8TH & COLUMBIA

RECOMMENDATION MEETING | DPD #3013479 | AUGUST 21ST, 2013

EDG GUIDANCE AND APPLICANT RESPONSES

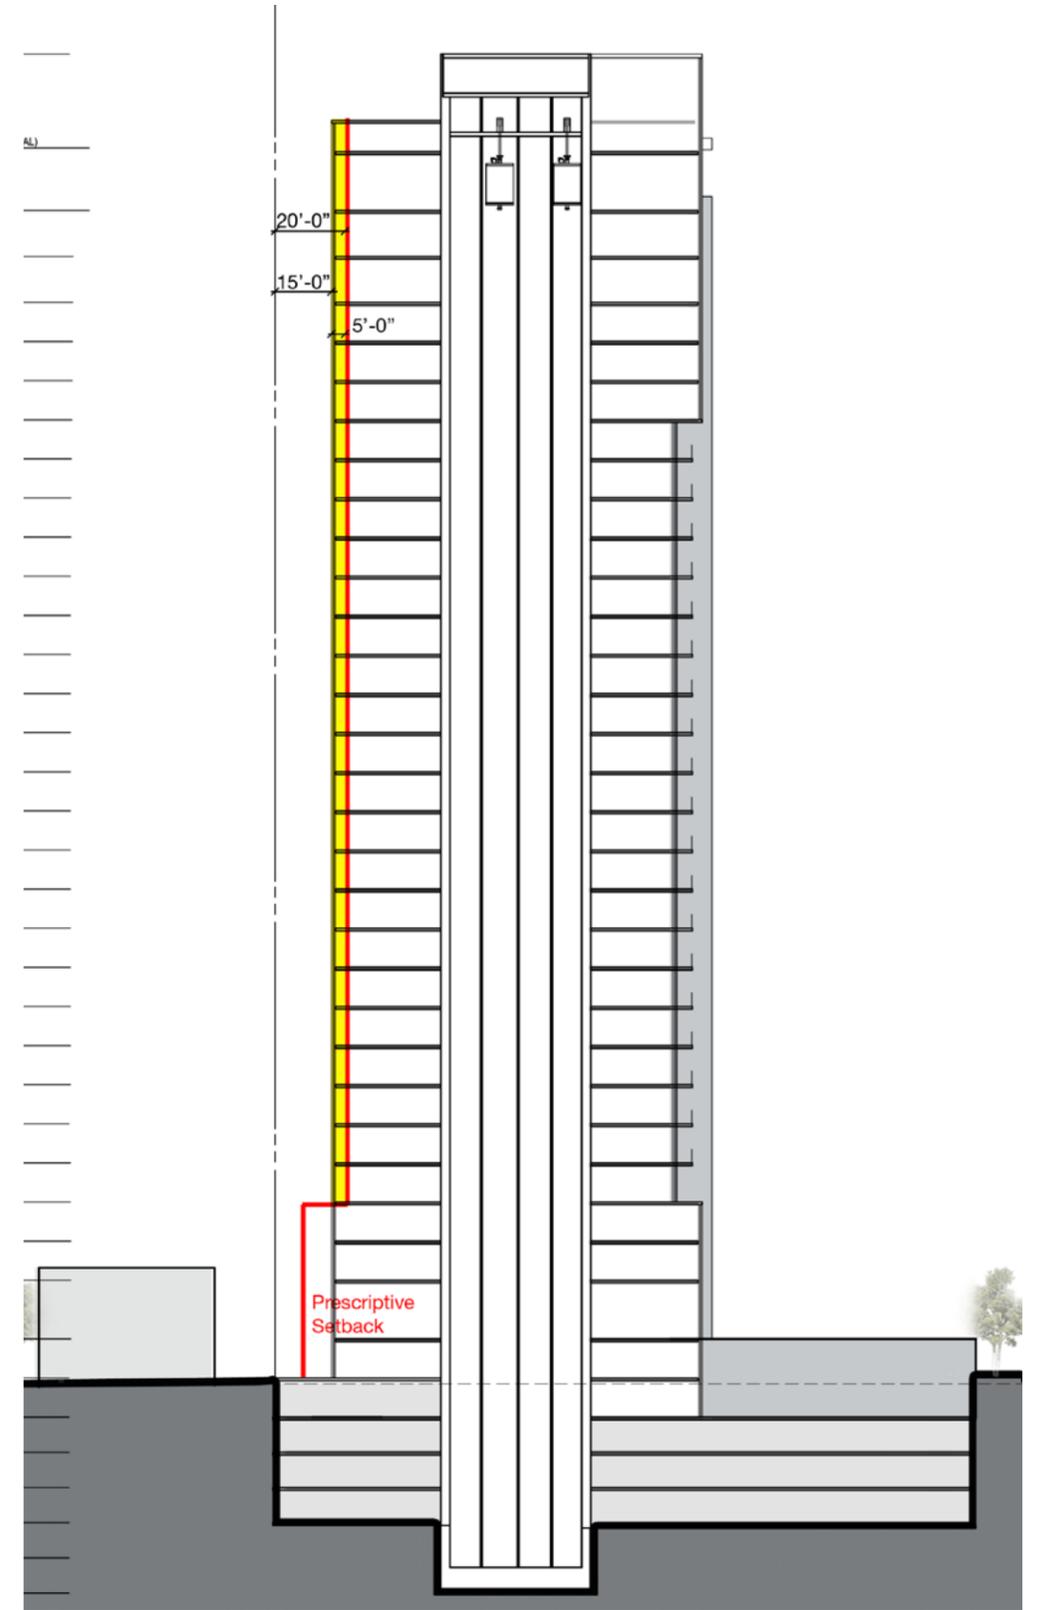
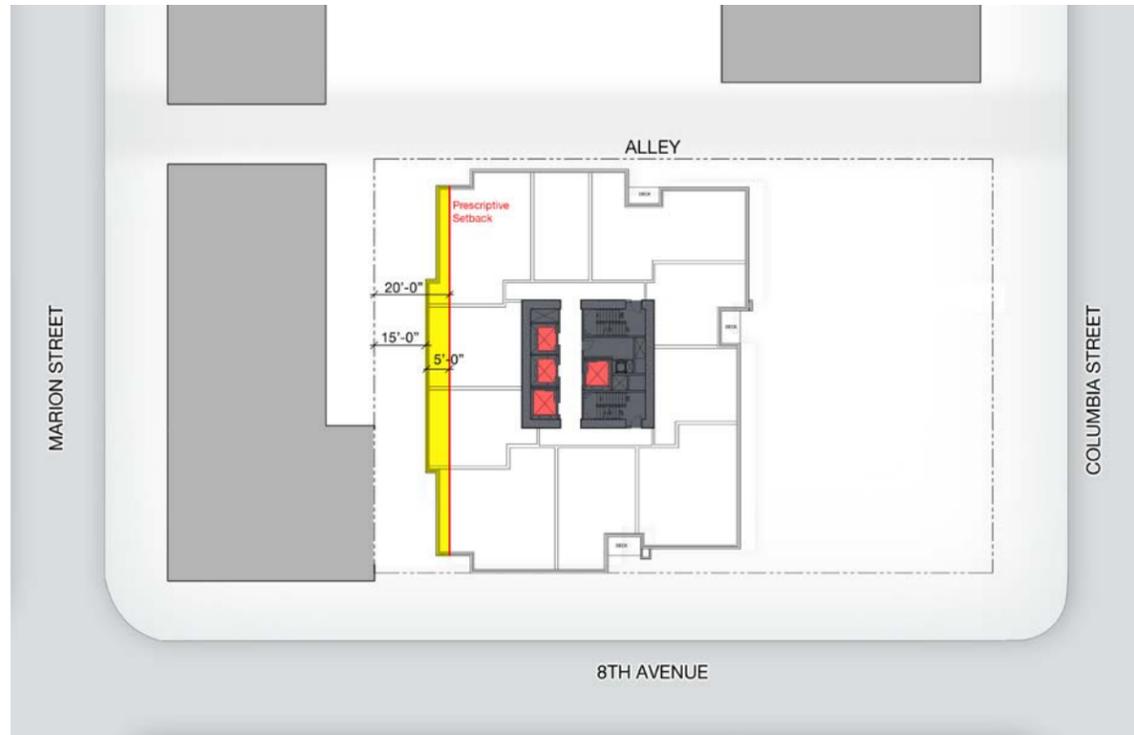
PRESCRIPTIVE At lot lines abutting neither a street nor alley: Portions above 45': 20' minimum setback

PROPOSED At lot lines abutting neither a street nor alley: Portions above 45': 15' minimum setback

CONSIDERATIONS This allows for a 5' larger open space. Provides 15' setback below 45' versus the code minimum 5' setback and 7' average.

DEPARTURE 2

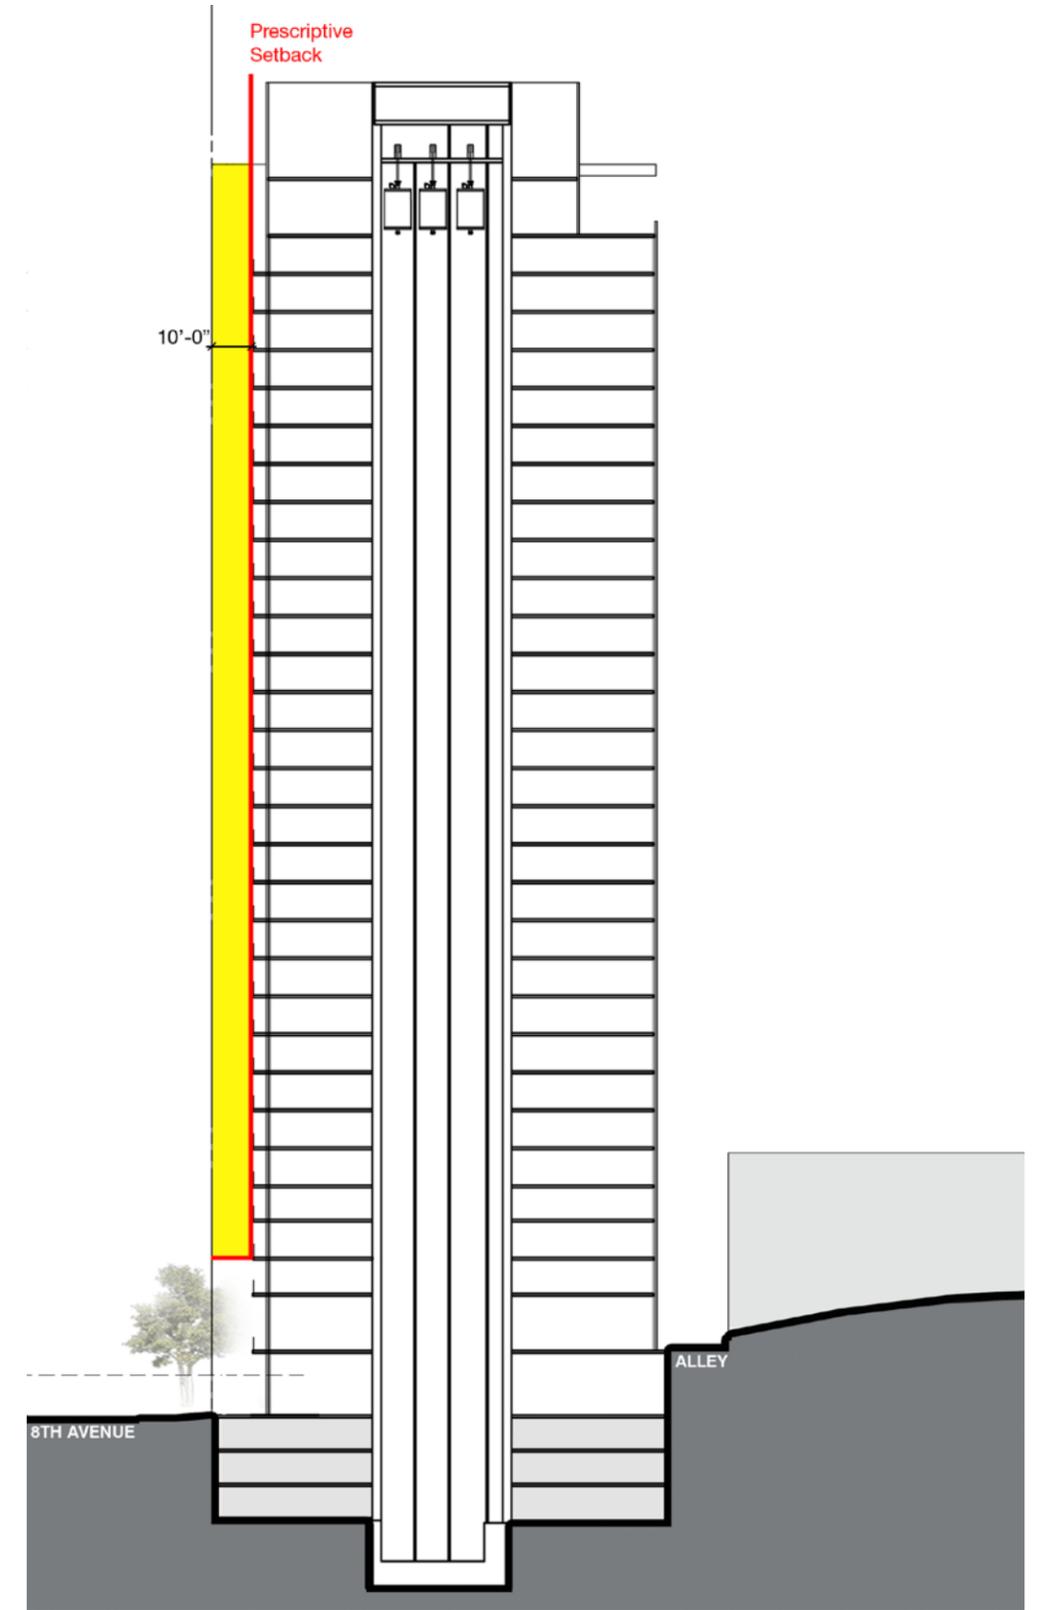
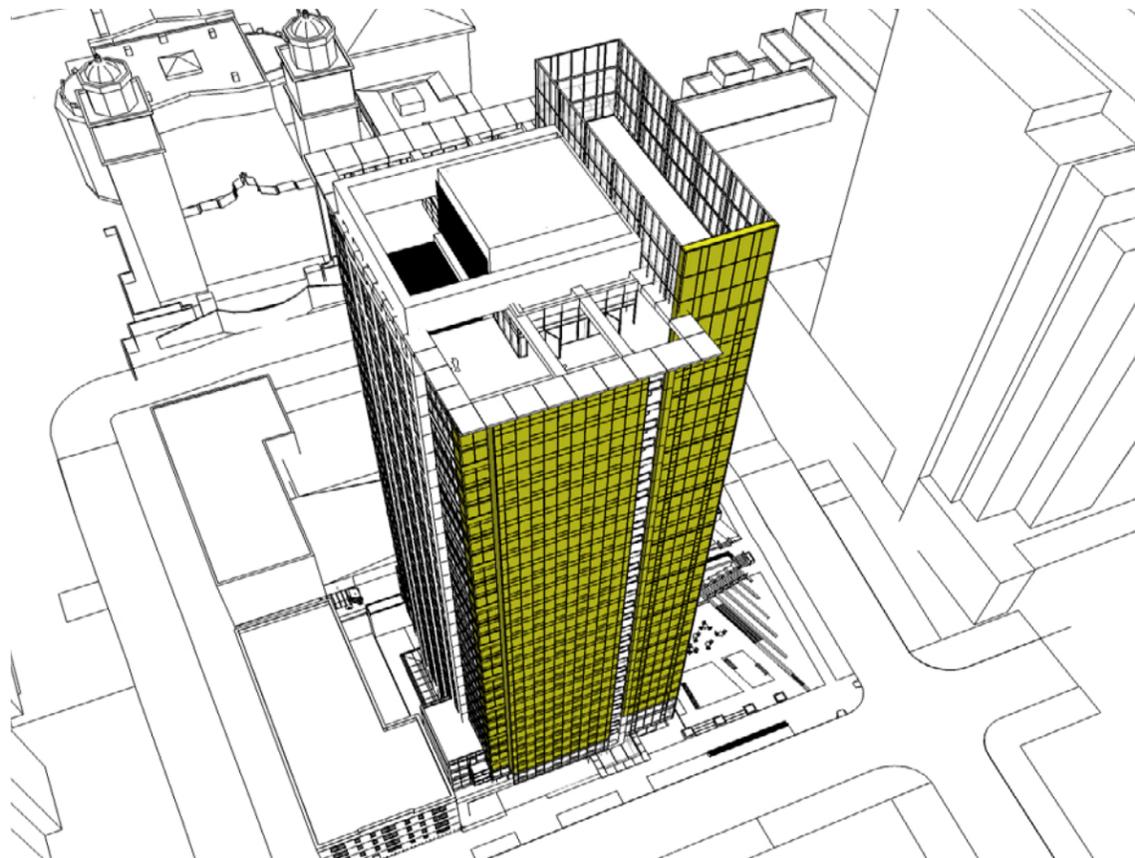
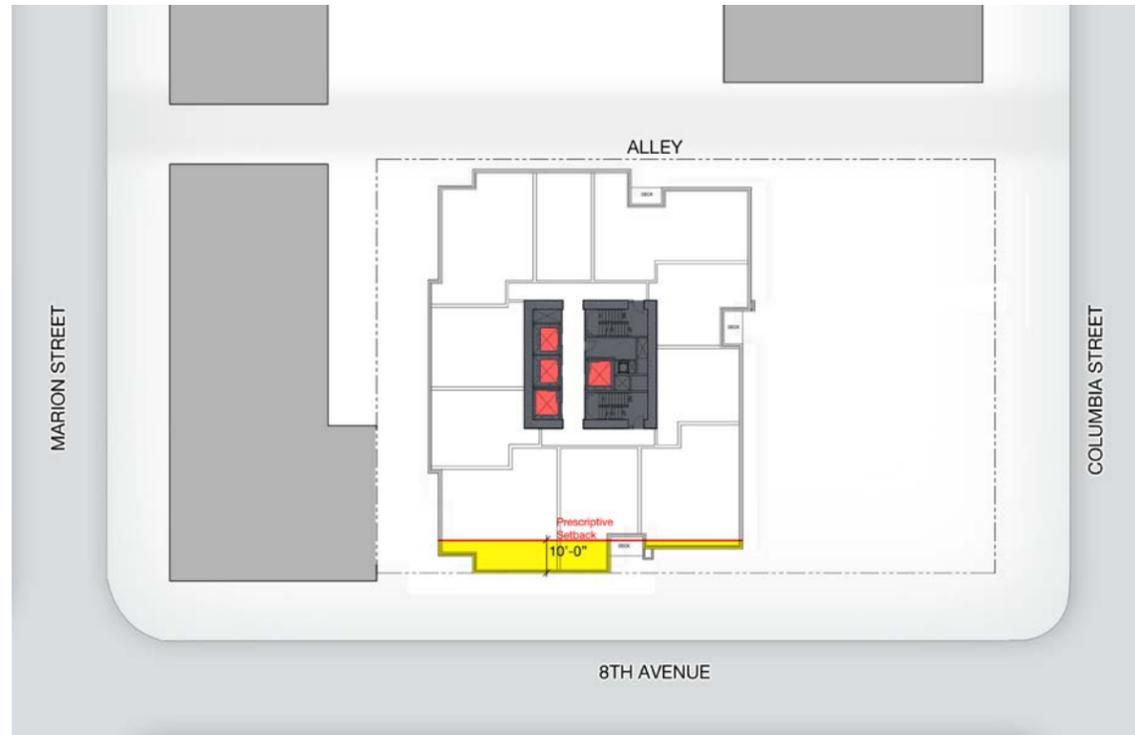
PRESCRIPTIVE At lot lines abutting the street:
Portions above 45': 10' minimum setback

PROPOSED At lot lines abutting the street:
Portions above 45': 0' setback

CONSIDERATIONS Slenderizes the building in the North-South direction. This allows a larger open space on the Southeast corner of the site.

DEPARTURE 3

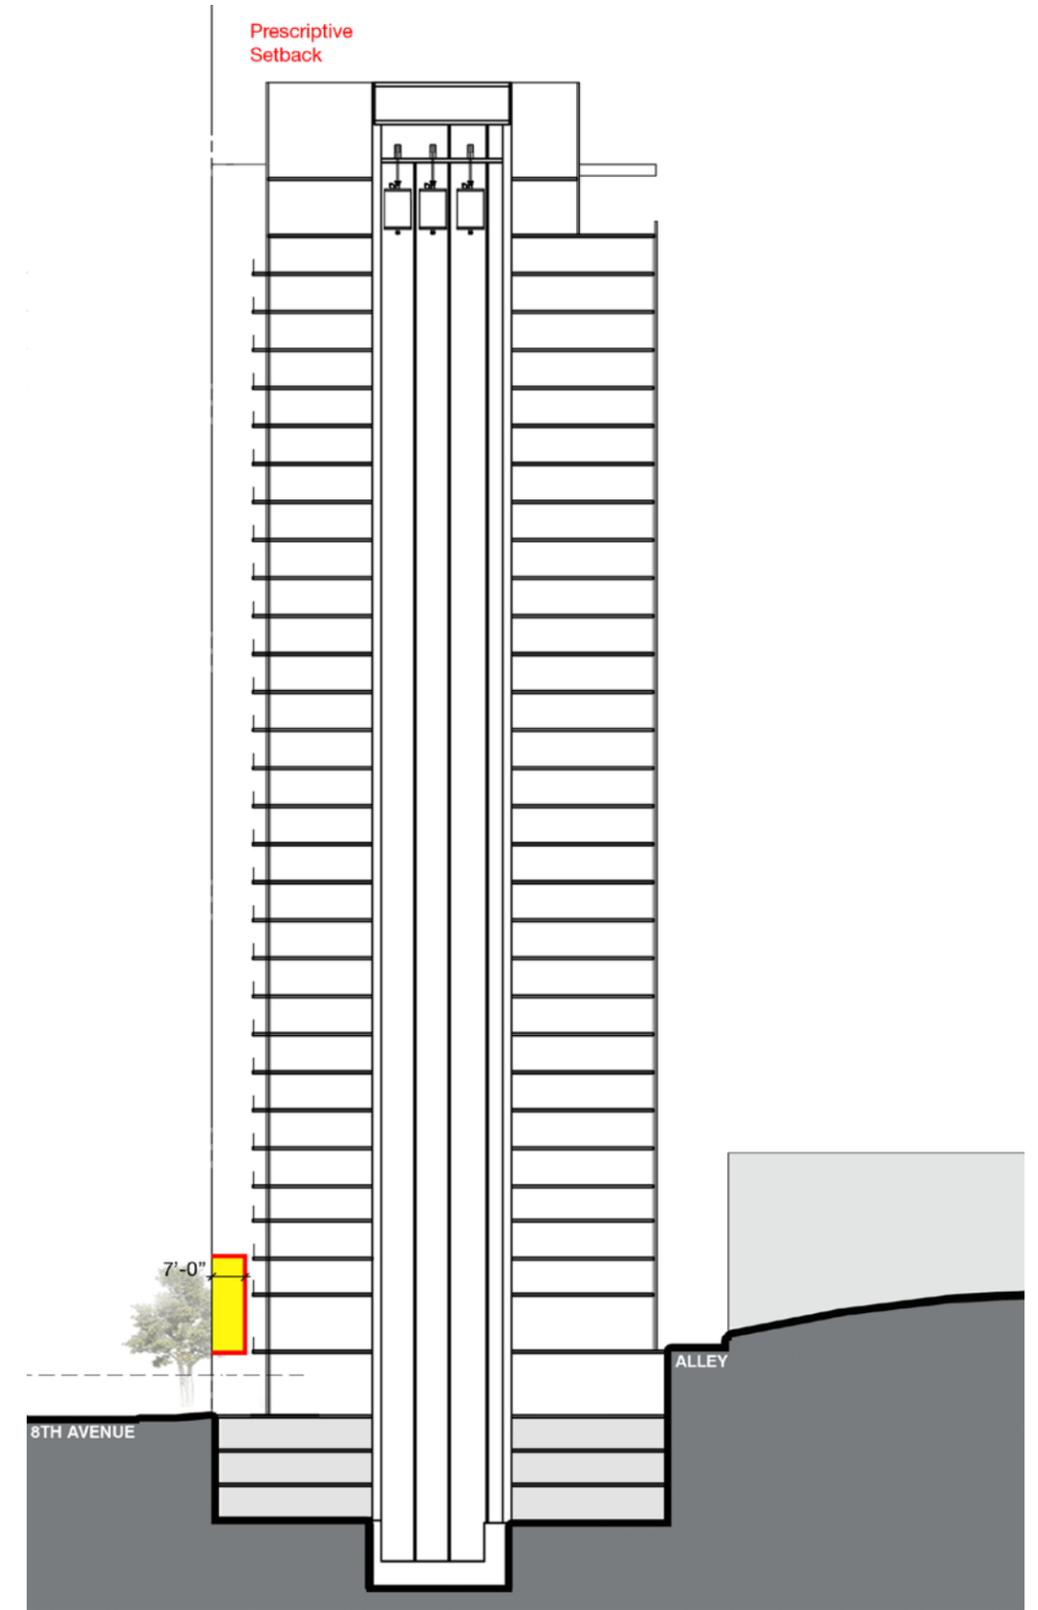
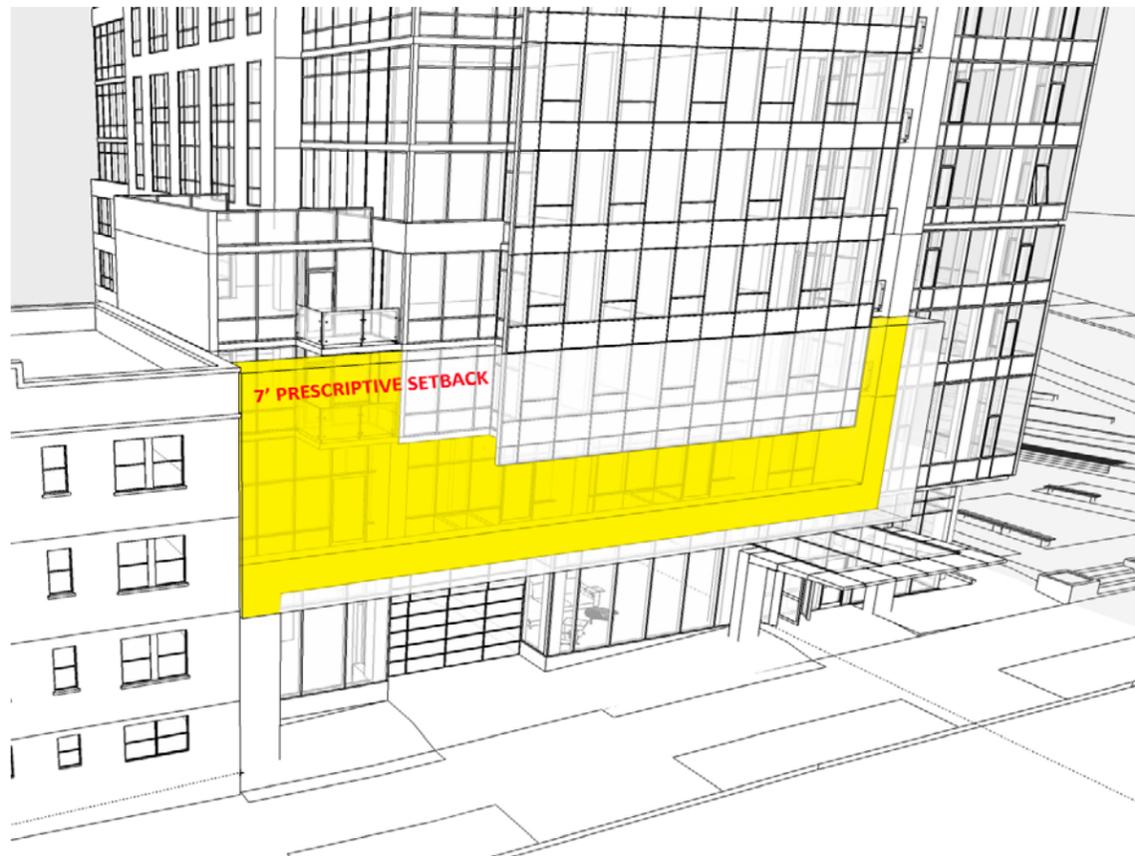
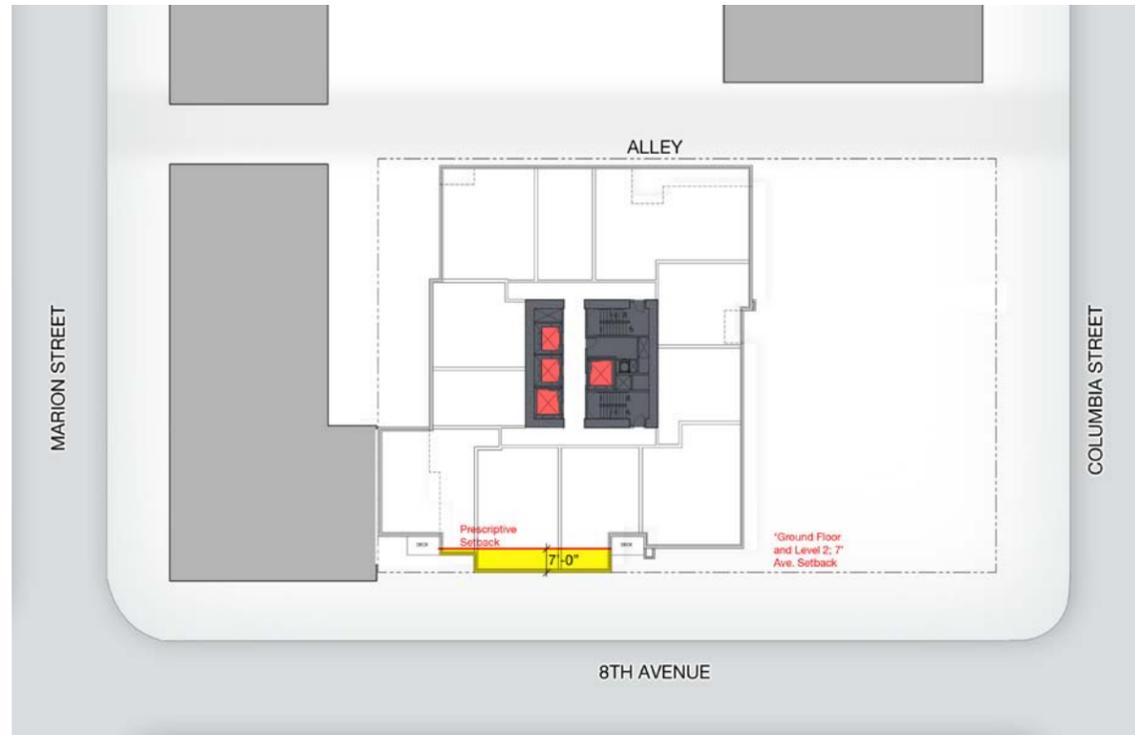
PRESCRIPTIVE At lot lines abutting the street:
Portions below 45': 7' average setback

PROPOSED At lot lines abutting the street:
Portions below 45' and above 18':
0' setback. Ground floor level; 10' average setback.

CONSIDERATIONS Aligns with facade above 45'. Creates a visual relationship to neighbor (Clarwood Apartments) and gives relief to the green street along 8th Avenue.
